Access Compliance Report

Public Rights-of-Way

(Curb Ramps)

Intersection ID: 14746	Main Street: ALBEMARLE_RD	Cross Street: WILGROVE_MINT_HILL_RD	Location: SE
ADA ID: 2FFC3D17FF87	Ramp Type: Perp	Initial Pass/Fail: Fail	Overall Compliance: No
Severity Score: 21.25			
Codes/Mitigation Info/Possible Solution		Field Measurements/Component Compliance

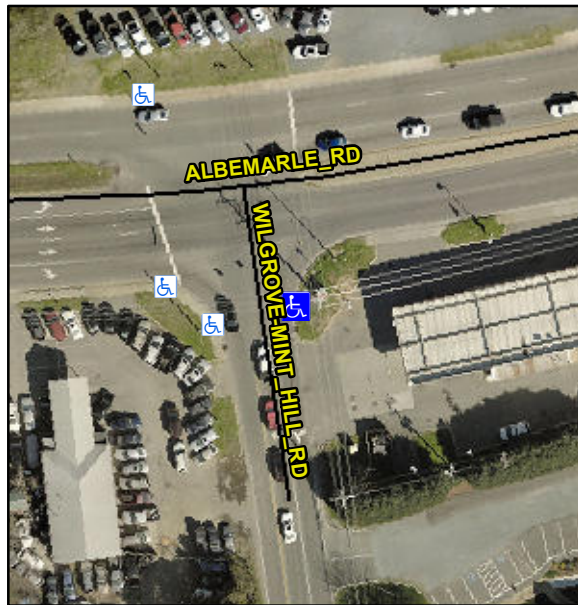
Not Found, R304.5.1, R304.2.2

Compliance	Description	Data	Compliance	Description	Data
N/A	Ramp Length (in)	64.0	No	Ramp Slope (%)	8.7
No	Ramp Width (in)	38.0	Yes	Ramp XSlope (%)	1.8
N/A	Flare Type LT	N/A	N/A	Flare Type RT	N/A
N/A	Flare Slope LT (%)	N/A	N/A	Flare Slope RT (%)	N/A
N/A	Flare Traversable LT?	N/A	N/A	Flare Traversable RT?	N/A
N/A	Landing Length (in)	N/A	N/A	DWS Provided?	N/A
N/A	Landing Width (in)	N/A	N/A	DWS Contrast?	N/A
N/A	Landing Slope (%)	N/A	N/A	DWS Length (in)	N/A
N/A	Landing X Slope (%)	N/A	N/A	DWS Full Width?	N/A
N/A	Landing Curb? (Y/N)	N/A	N/A	DWS Offset (in)	N/A
N/A	Shared Landing?	N/A			
N/A	Gutter Ponding?	Yes	N/A	Gutter Slope (%)	N/A
N/A	Gutter Lip Ht (in)	N/A	N/A	Gutter X Slope (%)	N/A
N/A	Painted X Walk1?	No	N/A	Painted X Walk2?	N/A
	X Walk 1 Direction	To W		X Walk 2 Direction	N/A
N/A	X Walk 1 Width (in)	N/A	N/A	X Walk 2 Width (in)	N/A
	X Walk 1 Slope (%)	0.0		X Walk 2 Slope (%)	N/A
	X Walk 1 X Slope (%)	2.2		X Walk 2 X Slope (%)	N/A

Remove & Replace Entire Ramp.
